Access Compliance Report

Public Rights-of-Way

Intersection ID: 44420	Main Street: PROVIDENCE PROMENADE DR S	Cross Street: PROVIDENCE PROMENADE DR S	Location: S
ADA ID: 27EE5CD1BD14	Ramp Type: Perp	Initial Pass/Fail: Pass	Overall Compliance: No
Severity Score: 2.5			
Codes/Mitigation Info/Possible Solution		Field Measurements/Component Compliance

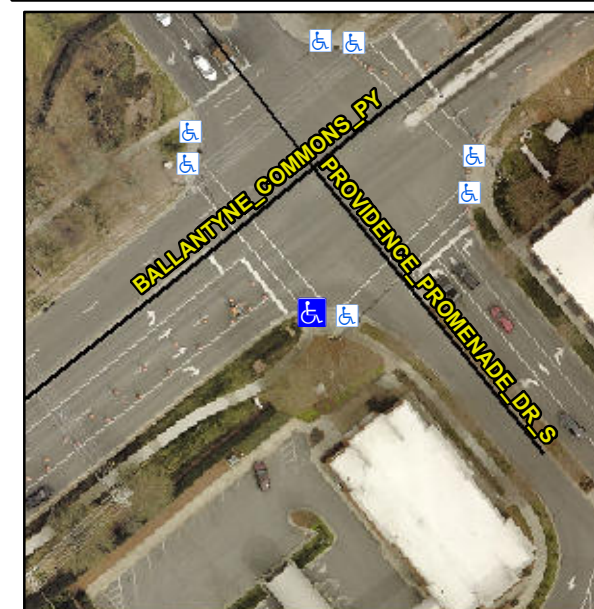
**R304.2.2-Perp, R304.3.2-Para,
R304.5.3, R305.1.4, R305.2**

Remove & Replace Entire Ramp.
